REMARKS

The drawings were objected to. The claims were objected to and applicants thank the Examiner for renumbering the claims. Claims 1 to 7, 12 and 13 were rejected under 35 U.S.C. 112, first paragraph.

New drawings for Fig. 2a and Fig. 3 have been submitted, as well as new drawings 5 and 6, and are respectfully submitted as clearly describing and enabling, together with the specification, the present invention as claimed.

Fig. 2a

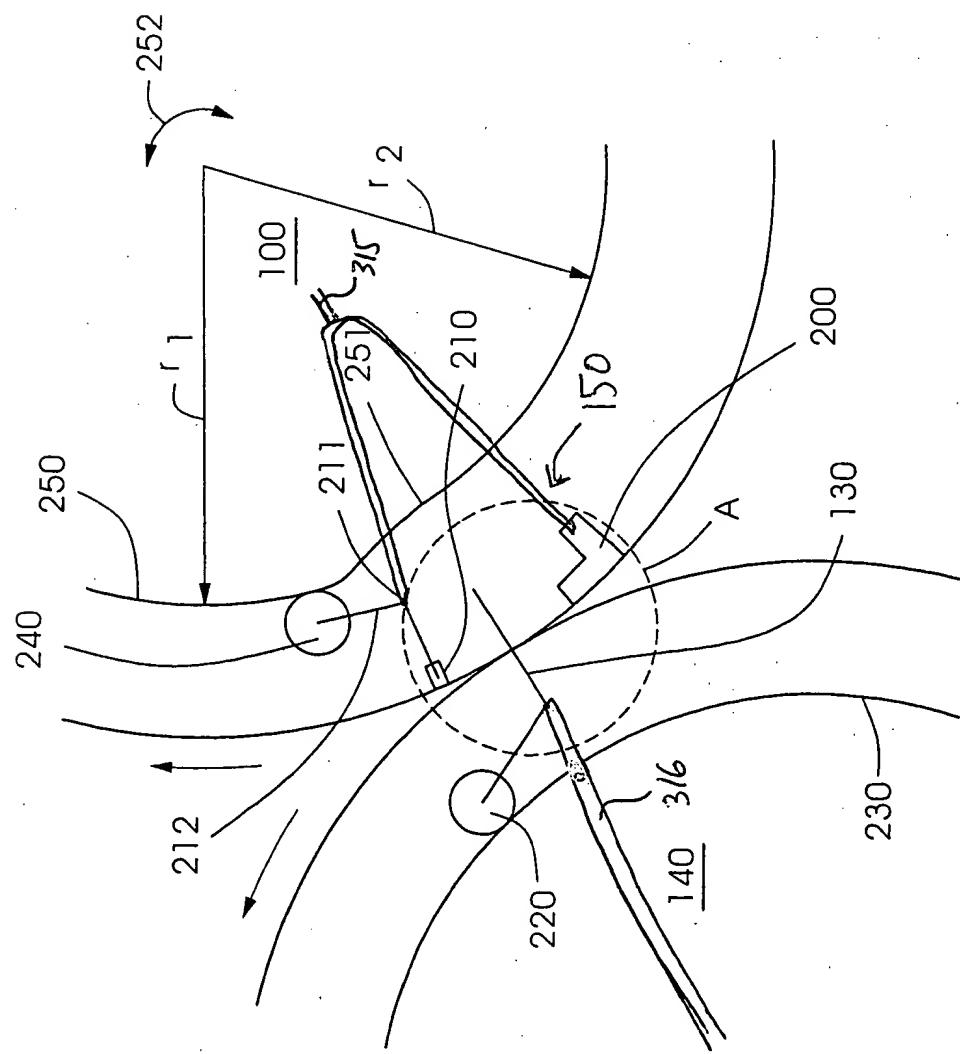
Fig. 2a has now been amended to show with more clarity how each spider, as shown also in Fig. 3, support the grippers 150 and tuckers 130.

With respect to claim 1, then, the specification describes a collect cylinder 100 having a gripper 132 and a tucker 130, and a jaw cylinder 100 with jaw 150 interacting with tucker 130, as also now shown in Fig. 2a. Jaw 150 has a stationary jaw part 200 and a movable jaw part 211

Fig.3

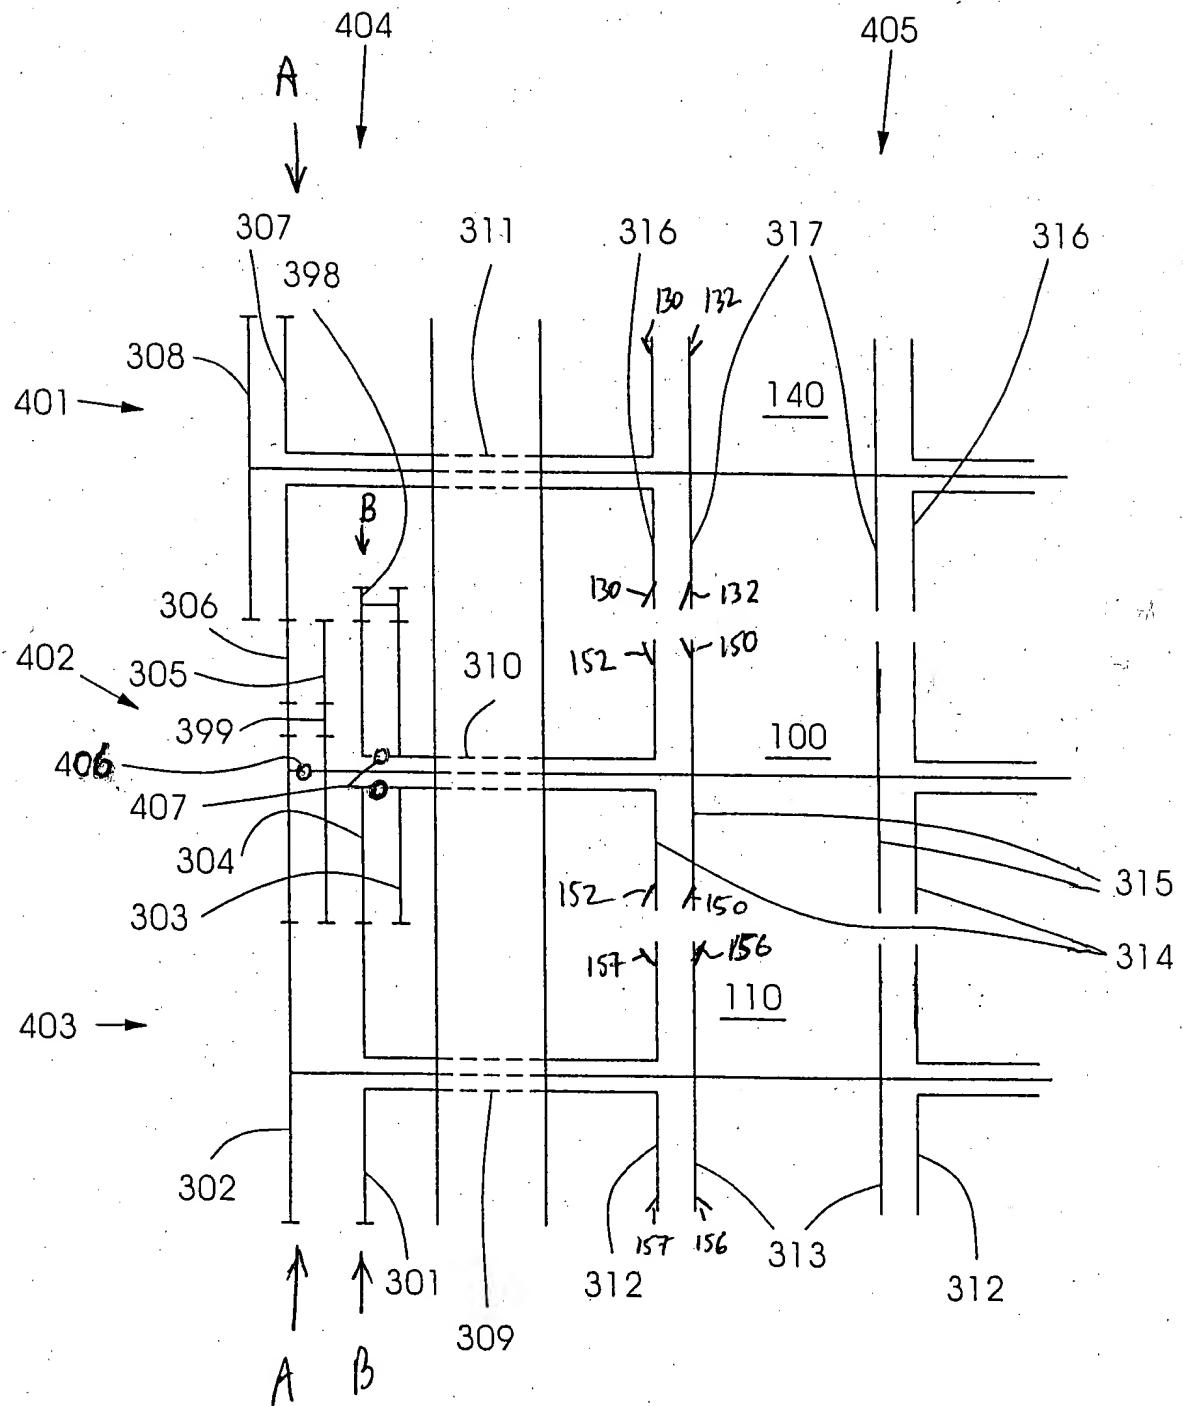
Fig. 3 has been amended to show the position of the gearing shown in Figs. 5 and 6.

FIG. 5

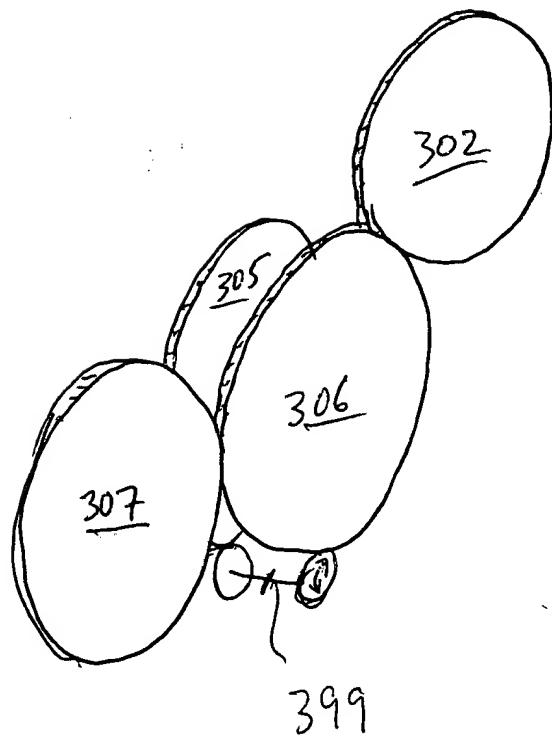
Figs. 5 and 6 show perspective views of the regions A-A and B-B, respectively.

With these views the adjusting via adjusting center 399 is clear as described in the specification: gear 307, which drives spider 316 and tuckers 130, is geared via gear 306, adjusting center 399, gear 305, and spider 315 to jaws 150, which have the fixed jaw part 200 of Fig. 2A. Adjusting center 399, for example using a helical gear, alters the phase between gears 305/306, so that they rotate relative to one another. See [0037] to [0039] of the specification.
